SAFETY EVALUATION BY THE OFFICE OF NUCLEAR REACTOR REGULATION  
RELATED TO AMENDMENT NO. 131 TO FACILITY OPERATING LICENSE NO. NPF-3

THE CLEVELAND ELECTRIC ILLUMINATING COMPANY  
DAVIS-BESSE NUCLEAR POWER STATION, UNIT NO. 1

DOCKET NO. 50-346

# FIGURE 1

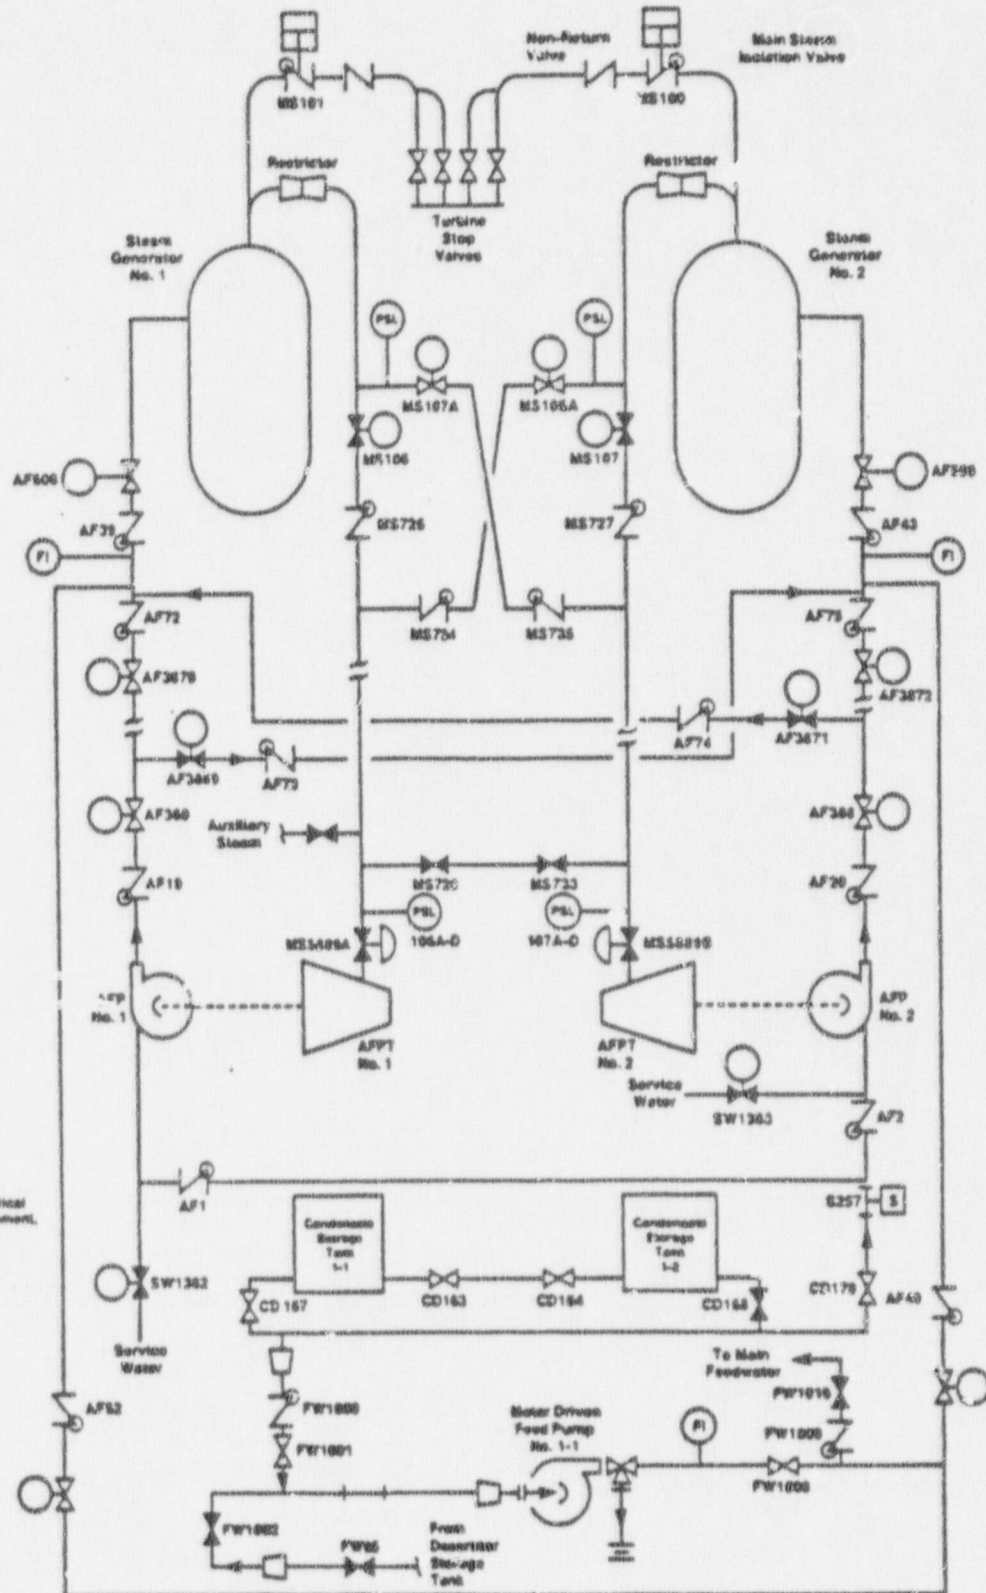
The present Davis-Besse Auxiliary Feedwater (AFW) system is shown in Figure 1, attached. Prior to the June 9, 1985 loss-of-feedwater event, valves MS-106, MS-106A, MS-107 and MS-107A, on the steam admittance lines to the AFW pump turbines, were retained in closed position. Thus, the portion of the steam admittance lines downstream of these valves remained at ambient pressure. Pressure switches PSL 106A through 106D were interlocked with motor operated steam admission valves MS 106 and MS106A while PSB 107A through 107D were

interlocked with steam admission valves MS 107 and MS 107A. These switches are designed to initiate closure of these four steam admission valves (or to maintain closure if already closed) in the event they detect low pressure. As initially designed, the steam admission valves were closed, and opened in response to a steam and feedwater rupture control system (SFRCS) signal. The pressure switches, originally in the tripped position because of sensing ambient pressure moved into the untripped position as a result of the pressure of the steam being admitted. Thereafter, a break in a steam admittance line which results in a lower pressure would cause the pressure switches to move into the tripped position, initiating closure of the steam admittance valves in the broken line.

It should be noted that the two air-operated valves, MS 5889 A and B shown on Figure 1 downstream of the pressure switch interlocks, were not part of that original design; they were introduced as part of the new design after the June 9, 1985 LOFW event and supplemented two manually operated valves which were kept in the open position. The new design also required that steam admittance valves MS 106A and 107A be kept open with MS 5889 A and B in the closed position. This has the effect of maintaining steam pressure in the lines up to valves MS 5889 A and B. Thus, while the pressure switches previously had to switch position from tripped to untripped in order to permit AFW system operation, now they remain in the untripped position and only operate (trip) in the event of a low pressure signal to shut off steam flow to the broken line.
